Santoft Groundwater Model and Rangitikei Groundwater Management Zone Allocation Limit Technical Review

Santoft Groundwater Model and Rangitikei Groundwater Management Zone Allocation Limit Technical Review

Dr Huma Saeed
Horizons Regional Council

Dr Hisham Zarour

Figure 4-34. Three-dimensional representation of the geology, groundwater management zone boundary (black line), model domain (red line), and rivers and streams (blue lines).

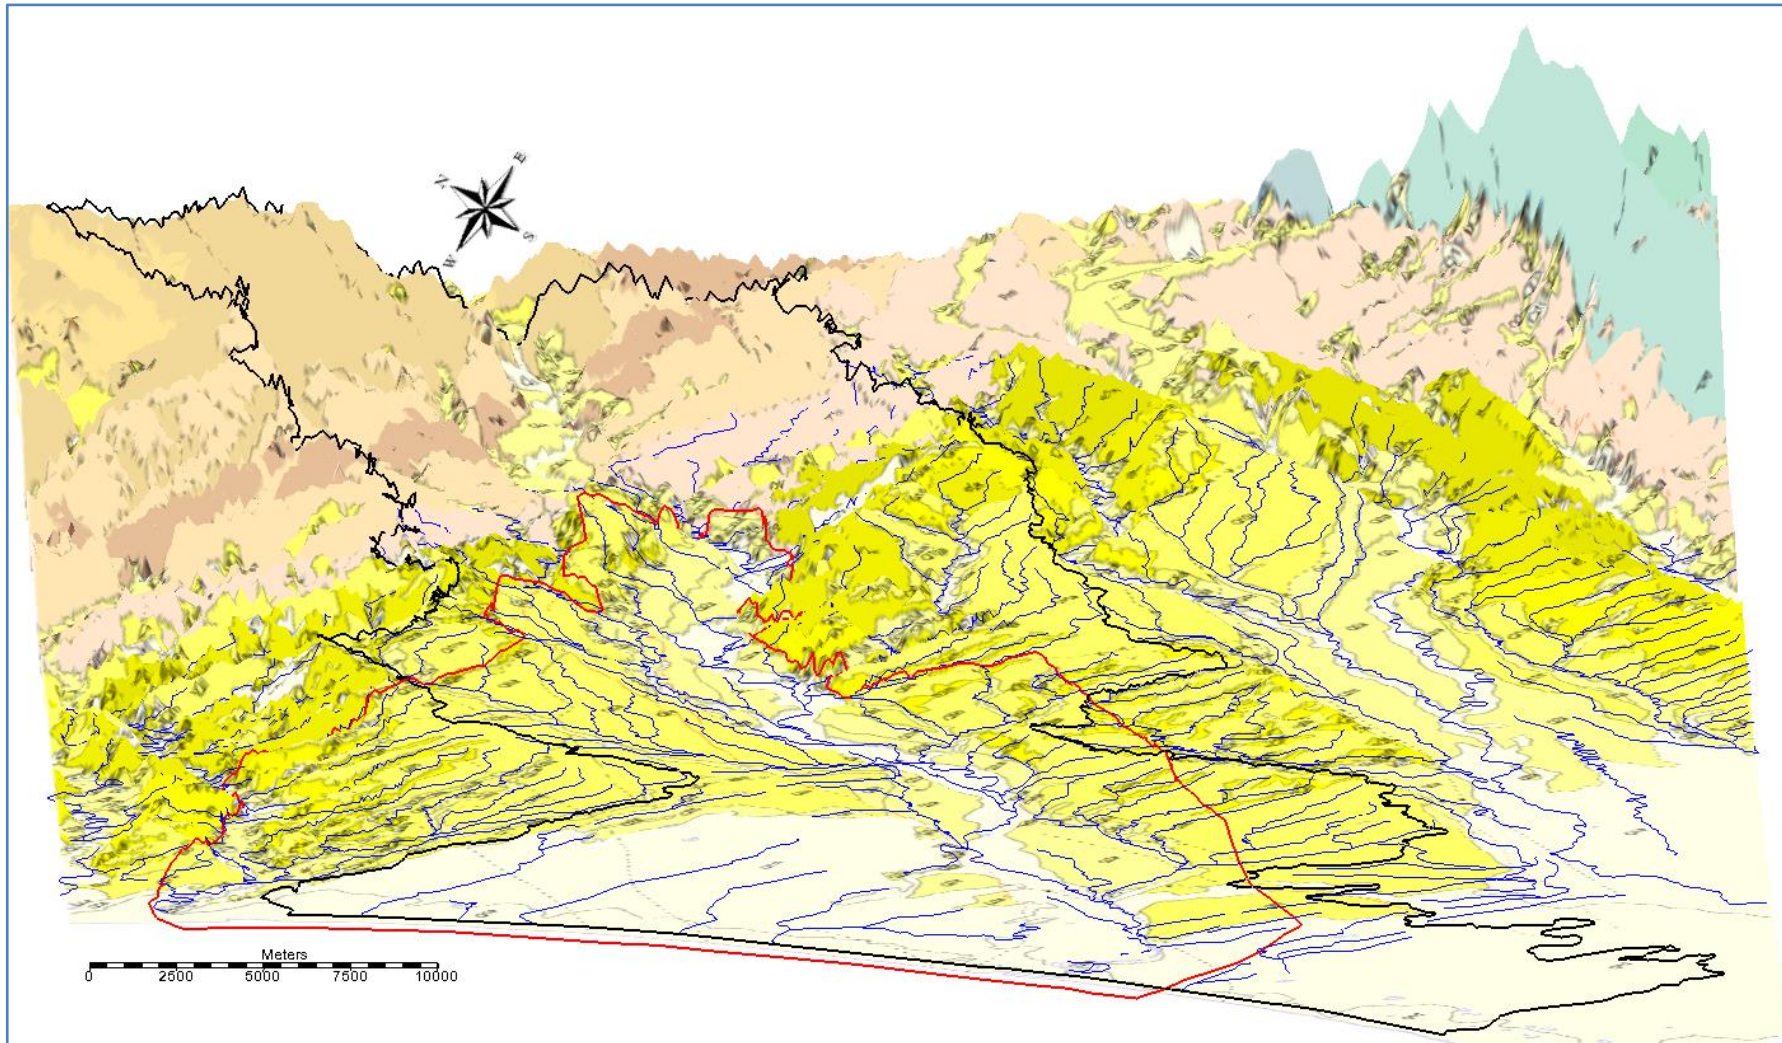
models produce very similar groundwater head estimates, highlighting the concept of non-uniqueness (different models can produce similar results). However, the predictions of different models most likely differ. Importantly, the models' boundaries do not respect hydrological principles; they cross surface water divides (catchment boundaries) and cut through waterways (Figure 4-34).
